Item 6.**Development Application: 2 Edward Street, Pyrmont - D/2019/726**

File No.: D/2019/726

Figure 19: Plans lodged with the application show that users of the end of journey facilities were required to use the shared driveway for multiple pedestrian movements, between the bike store, showers and internal stairs that provide access to the offices above (red arrows).

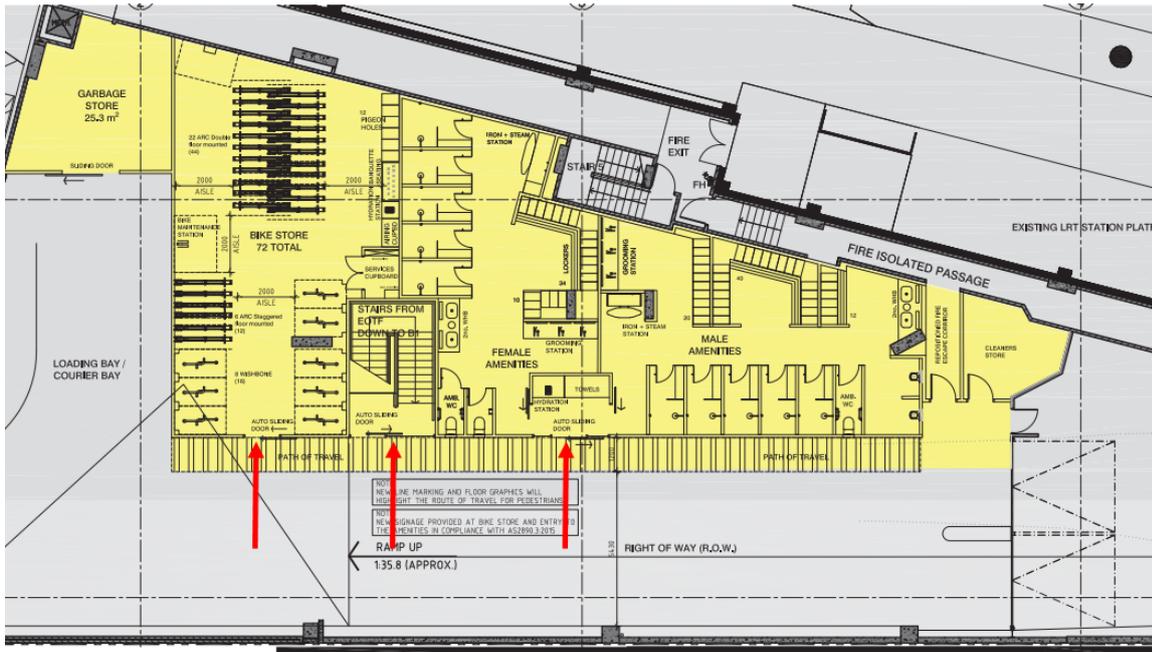
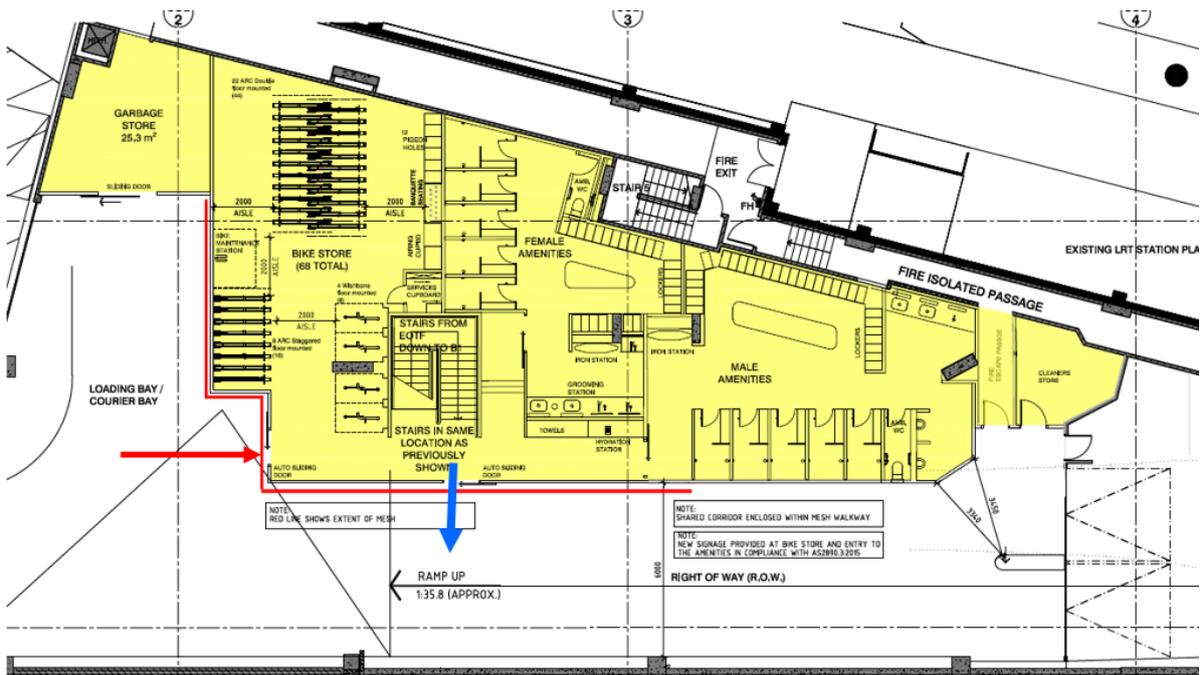
44. In response, the applicant has submitted amended drawings for the end of journey facilities, an updated Traffic and parking Statement (Attachment C) and a loading dock management plan (Figures 19 and 20 below).

45. The amended drawings show that aside from an emergency egress door at the southern edge of the facilities, there will be a single point of entry for cyclists using the end of journey facilities. The single point of entry is to be located at the western end of the facilities.

46. The amended drawings and Traffic and parking statement show that:
 - (a) users of the end of journey facilities are no longer required to use the narrow shared driveway to access the 3 previously proposed doors to the facilities. Entry will be provided via a single automatic door located at the western end of the facilities, within the wider driveway area that has good visibility;

Figure 20: Amended drawings showing that users of the end of journey facilities access the facilities and the staircase to enter the building via a single automatic door that is not located within the shared driveway area (red arrow). An emergency egress door is located at the southern end of the facilities (blue arrow).

Figure 21: Extract from the amended Traffic and parking Statement showing proposed line marking and signage within the shared zone.

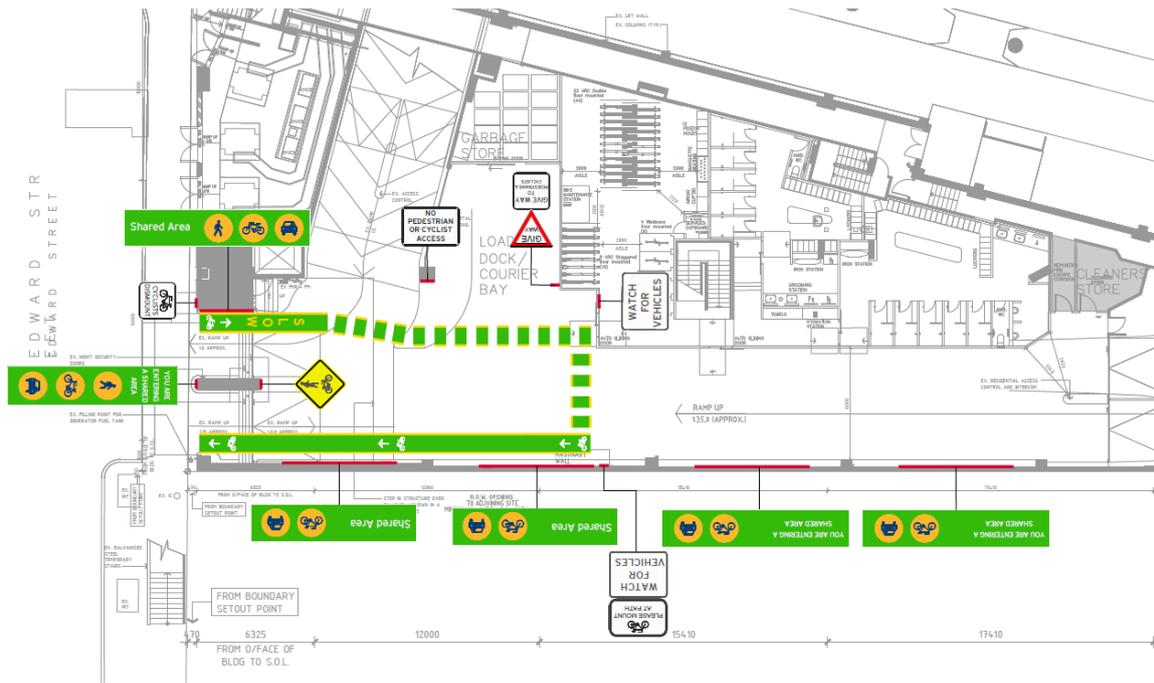
- (d) the installation of signage and line marking is recommended within the shared zones located in the driveway area (Figure 21 below).
47. The amended drawings and supporting documents provide a suitable layout for the end of journey facilities with regard for the safety of their users and vehicles using the shared driveway to access the residential Gateway Building. Council's transport specialists consider the amended approach to be acceptable.

Figure 22: Swept path diagram demonstrating that a medium rigid service vehicle can safely enter the Gateway Building. Note: drawings have been amended to widen the shared driveway at the eastern end from 6m to 6.1m.

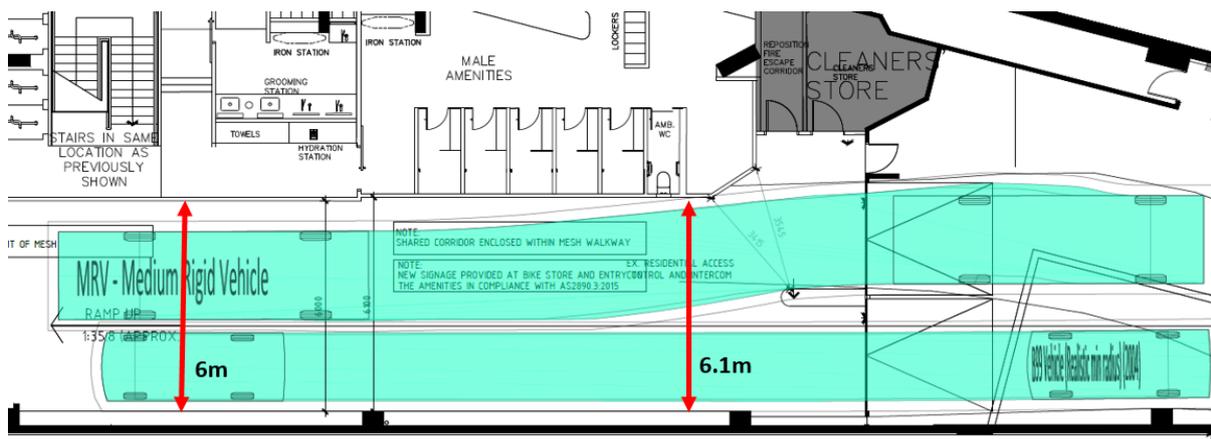
- (c) swept path diagrams have been provided, which demonstrate that medium rigid service vehicles can safely enter the Gateway Building (see Figure 22 below); and

Response - Amended drawings and swept path diagrams demonstrate that the width of a shared driveway that provides access for medium rigid service vehicles to the Gateway Building is satisfactory. Refer to discussion above and Figure 22.
